Balboa Park Central Mesa

Precise Plan

Proposed Amendment for
Plaza de Panama, Circulation, and a Parking Structure

April 5, 2012
Sixth Draft

Open Public Park Land – Proposed Plan

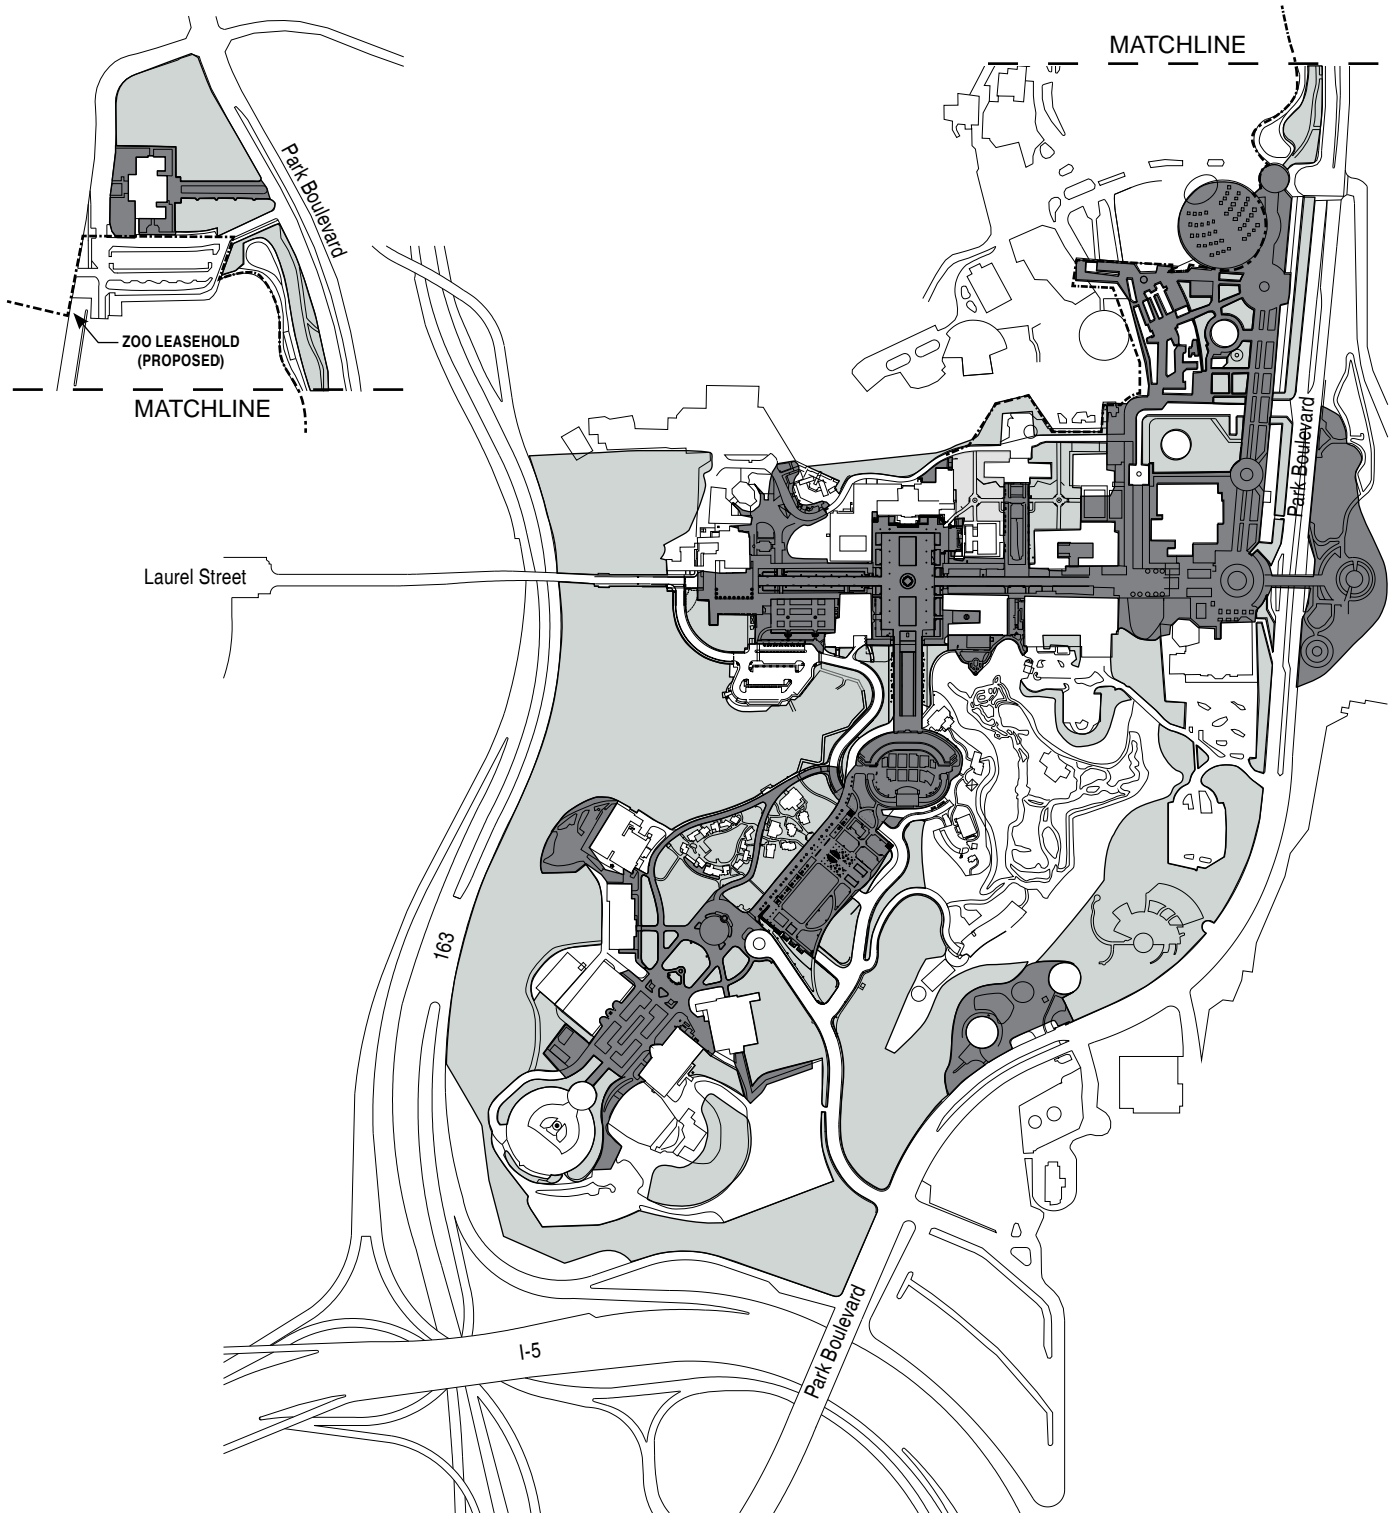
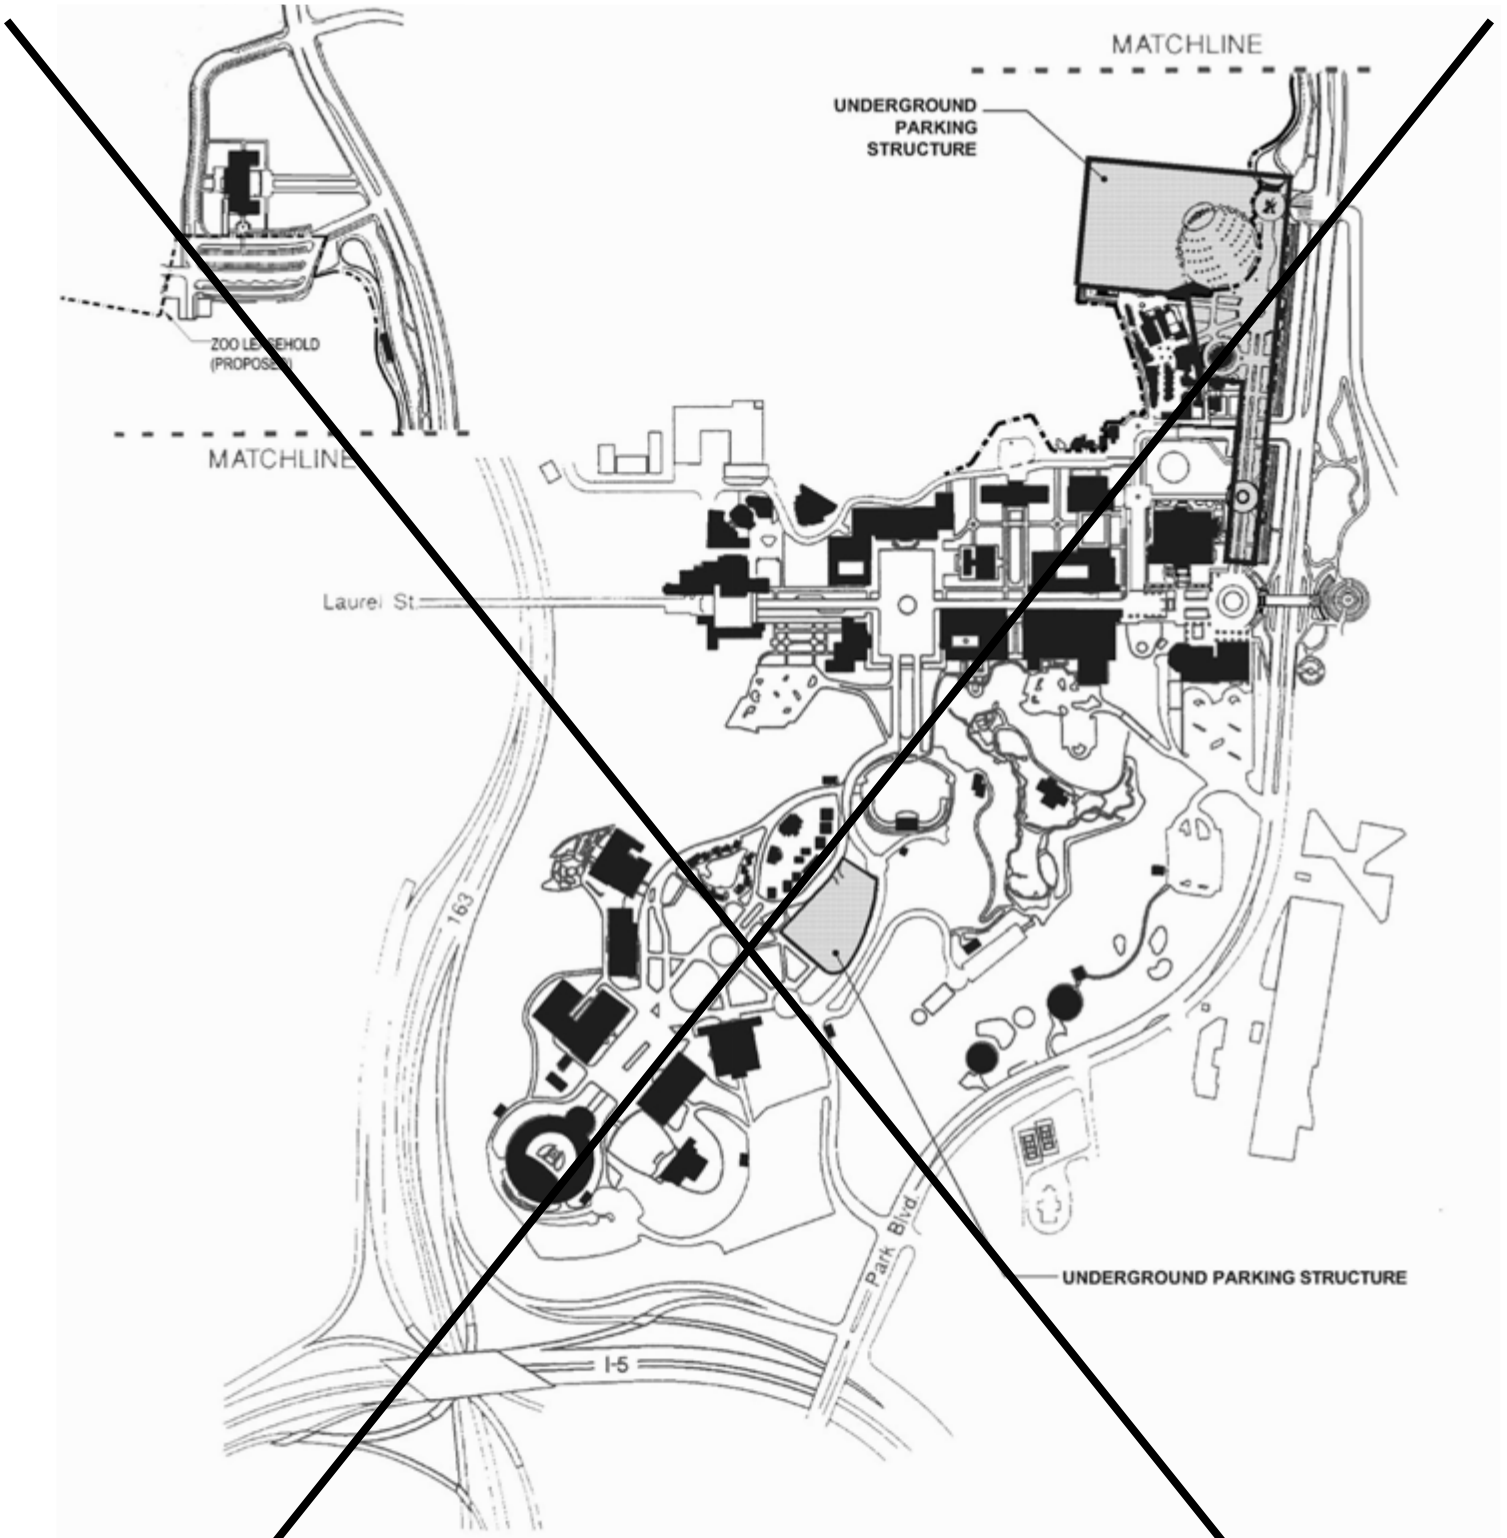
- Open Public Park Land Recovered from other Uses – **32 33** acres
- Open Public Park Land Converted to other Uses – **27 5** acres

Proposed Vehicular Circulation and Parking

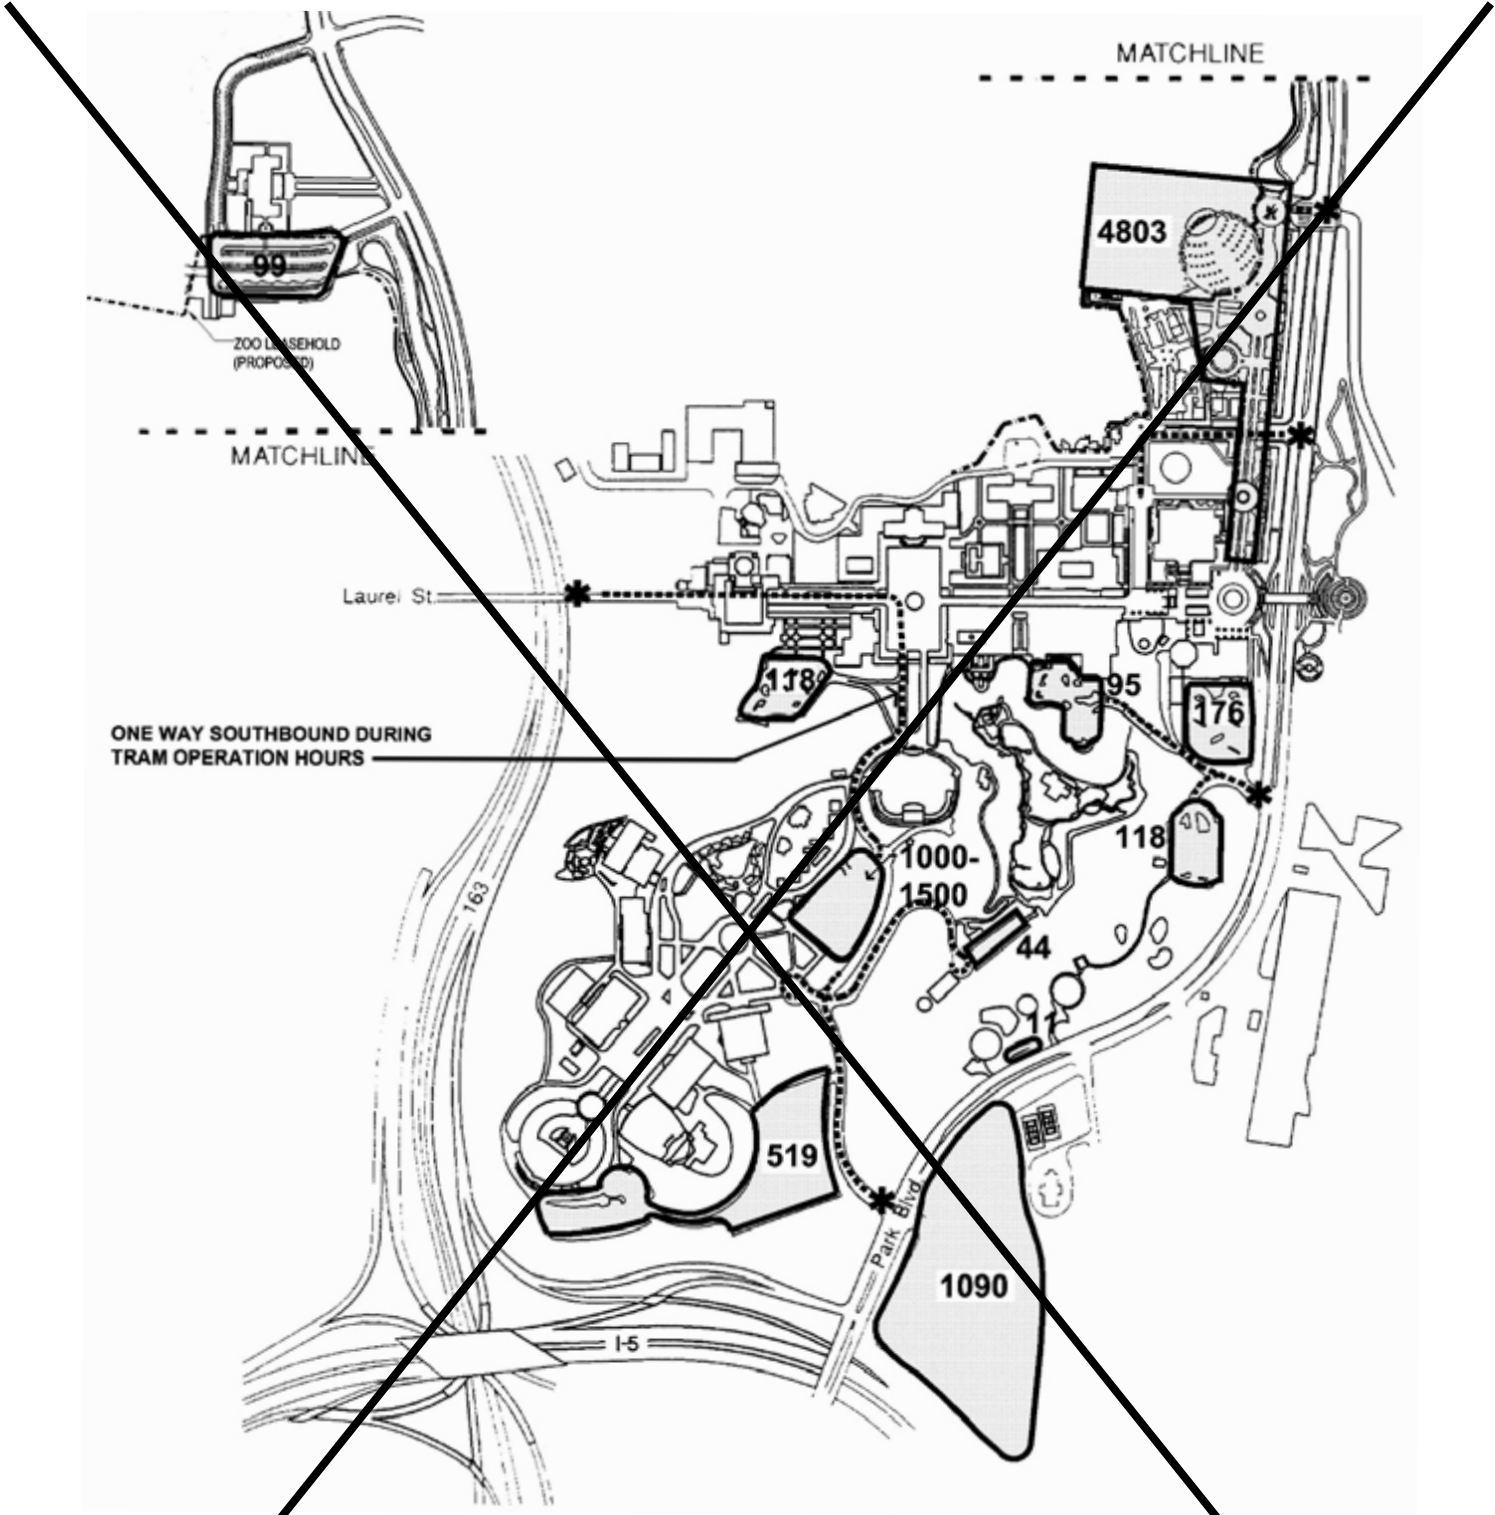
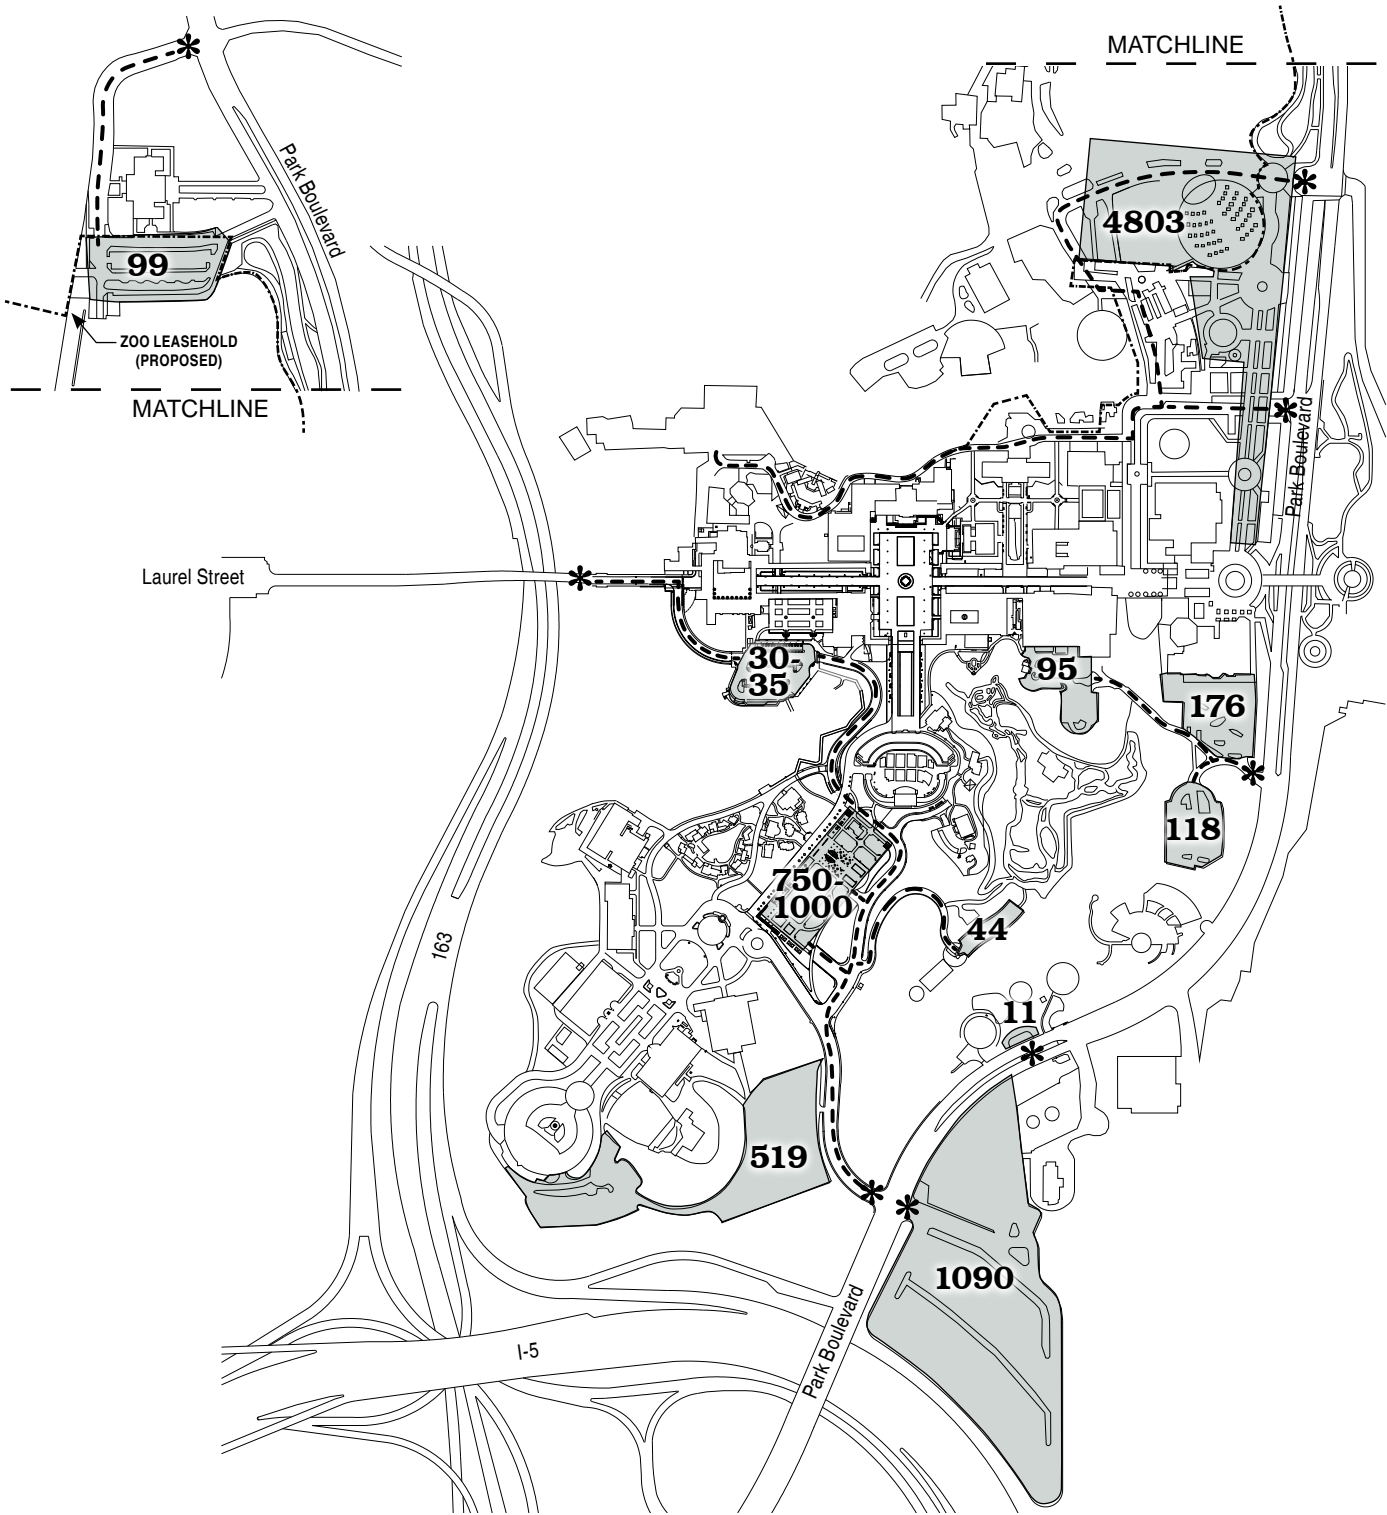
** Organ Pavilion parking garage design to accommodate ~~1,000 – 1,500~~ 750-1,000 parking spaces.

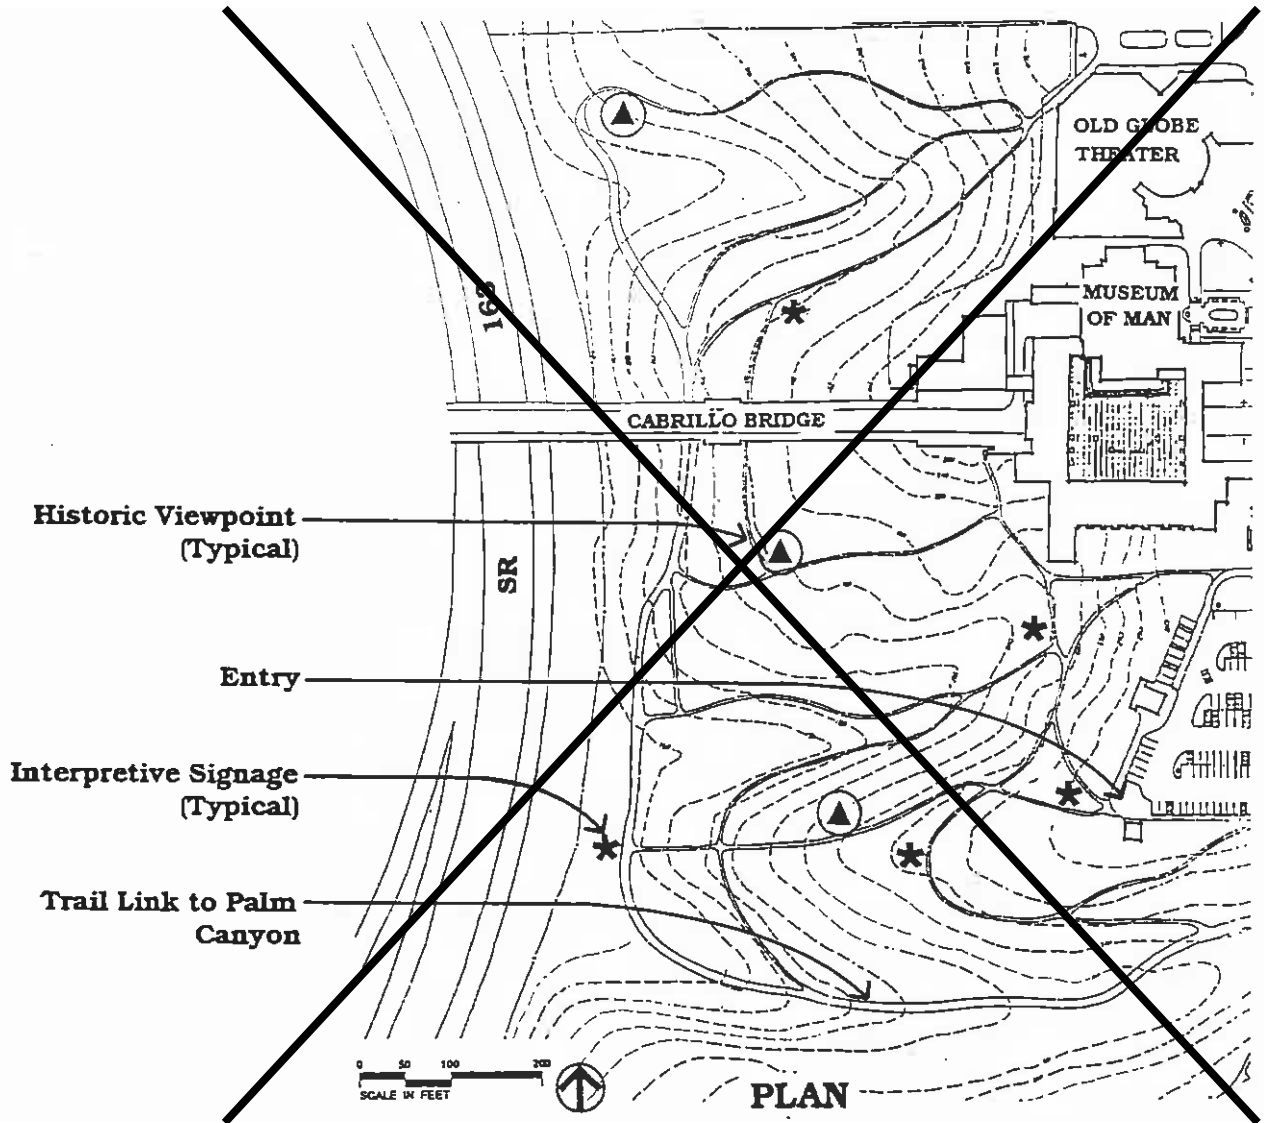
Modify the West Prado in order to ~~provide for automobile turnout lanes while re-establishing~~ re-establish as much of the historical character of this processional space as possible.

- Replace asphalt with decorative concrete paving to ~~match~~ complement existing East Prado paving surface.
- Install a pedestrian drop-off lane on each side of the vehicular circulation lanes as shown on the plan.
